UNITED STATES
NUCLEAR REGULATORY COMMISSION
WASHINGTON, D. C. 20555

FACILITY: Watts Bar Nuclear Plant, Units 1 and 2

SUBJECT: SUMMARY OF MEETING TO DISCUSS EXEMPTION REQUEST TO ITEM II-F-1
OF NUREG-0737 FOR THE WATTS BAR NUCLEAR PLANT, UNITS 1 AND 2

AUXILIARY BUILDING VENT STACK

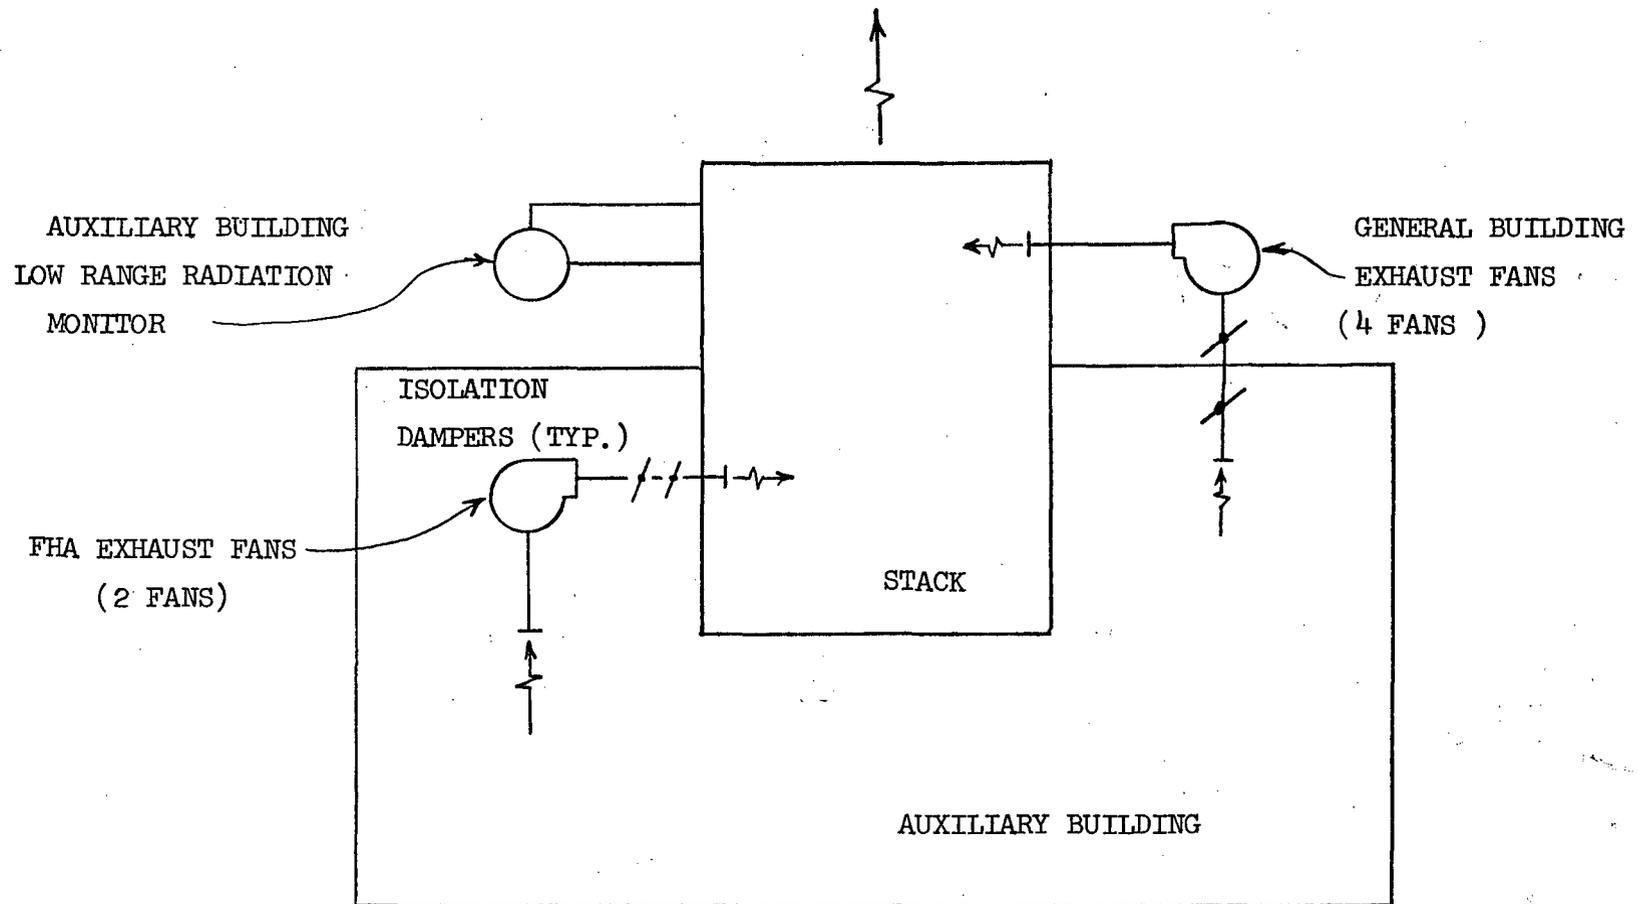
By letter dated November 22, 1983, TVA requested that an exemption be granted from installing high-range noble gas monitors on the auxiliary building vent. The Applicant provided the attached handout (Enclosure 2) and presented a detailed explanation of the operation of the auxiliary building and shield building ventilation systems. TVA stated that the monitor was not necessary since the auxiliary building ventilation system would be isolated by an Engineered Safety Feature System. This system could not be easily overridden, so exhausting through the vent would require deliberate action of the operator. In addition, if it became necessary to vent through the auxiliary building vent, air samples could be taken with portable samplers.

The staff told TVA that there did not seem to be anything unique at Watts Bar to distinguish it from other similar facilities to justify non-installation of the monitor on the steam generator safety and PORV release lines, and therefore, could not justify the exemption on the TMI-related item. However, the staff stated that the justification presented on the exemption regarding the monitor on the auxiliary building vent supported the exemption request, and asked TVA to docket the information presented during the meeting. Upon receipt of that information a final determination will be made on the request.
